UNITED STATES PATENT AND TRADEMARK OFFICE

APPLICATION NO.	FILING DATE	FIRST NAMED INVENTOR	ATTORNEY DOCKET NO.	CONFIRMATION NO.
10/531,513	11/01/2005	Theodor Gerhard Rosch	169-85304	9097
22342 7590 06/09/2009 FITCH EVEN TABIN & FLANNERY 120 SOUTH LASALLE STREET SUITE 1600 CHICAGO, IL 60603-3406				
EXAMINER				
OU, JING RUI				
ART UNIT		PAPER NUMBER		
3773				
MAIL DATE		DELIVERY MODE		
06/09/2009		PAPER

Office Action Summary**Application No.**

DETAILED ACTION

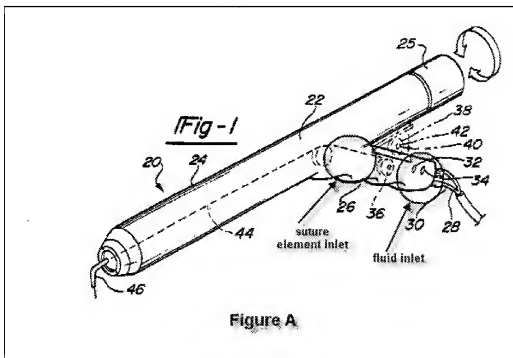
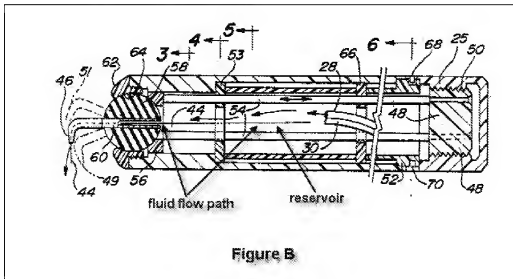
2. The amendment filed 03/16/2009 is objected to under 35 U.S.C. 132(a) because it introduces new matter into the disclosure. 35 U.S.C. 132(a) states that no amendment shall introduce new matter into the disclosure of the invention. The added material which is not supported by the original disclosure is as follows: Fig A and Fig B.

In regard to Claims 22-31, Weng discloses a medical implement (20), which includes a body (24) defining: tissue penetration device (46); a fluid flow path (see Figure B below); a fluid inlet (see Figure A below); an outlet (distal opening of 46); a suture element inlet (see Figure A below) which opens into the fluid flow path at a position intermediate the fluid inlet and the outlet; wherein the body defines a suture element feed path which intersect the fluid flow path at a position intermediate the fluid inlet and the outlet, the suture element feed path opening into the fluid flow path via the suture element inlet, the suture element feed path having a suture element feed opening which opens out of the medical implement through which the suture can be fed from the outside the medical implement into the suture element feed path and into the fluid flow path (Fig. 1, When door 38 is open, the spool of suture material is located outside the medical implement and can be fed from the outside the medical implement into the suture element feed path and into the fluid flow path); wherein the body defines a reservoir (see Figure B below); the implement includes releasable securing device; and a tissue drive device (channel of 60); and wherein the fluid inlet and the suture element inlet are provided by a single inlet into the fluid flow path.

Applicant is required to cancel the new matter in the reply to this Office Action.
